MSI Technical Bulletin 098

Subject: Updated Assembly Notes for VC-316-015 Seat/Insert Installation Tool

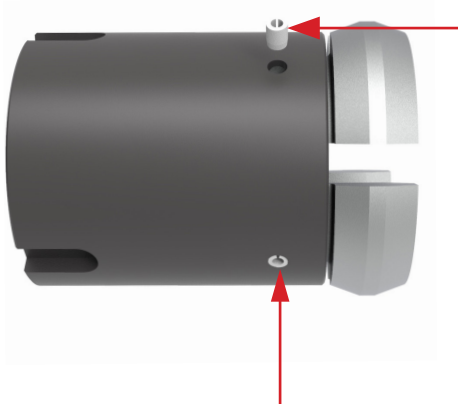
Ensure roll pins are flush with sleeve

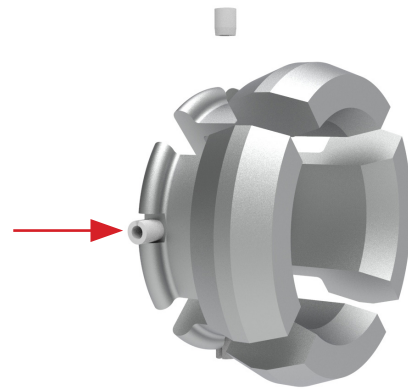
Ensure roll pins are positioned in keyways of fingers

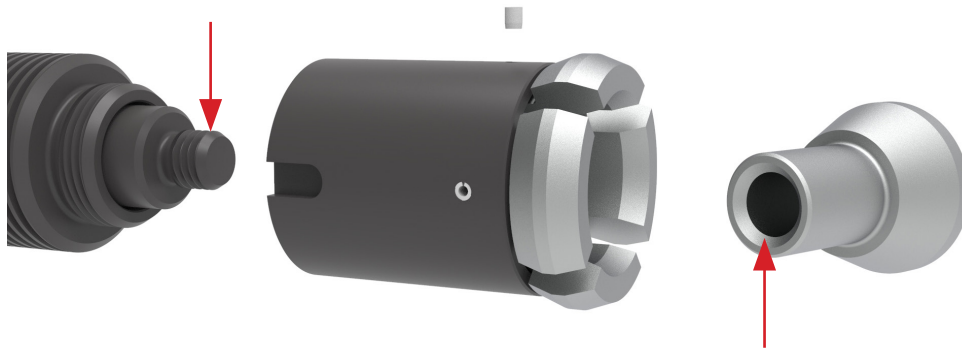
Add medium strength blue thread locker to shaft OD threads and to mandrel ID threads. Tighten mandrel 1/4 turn passed hand tight
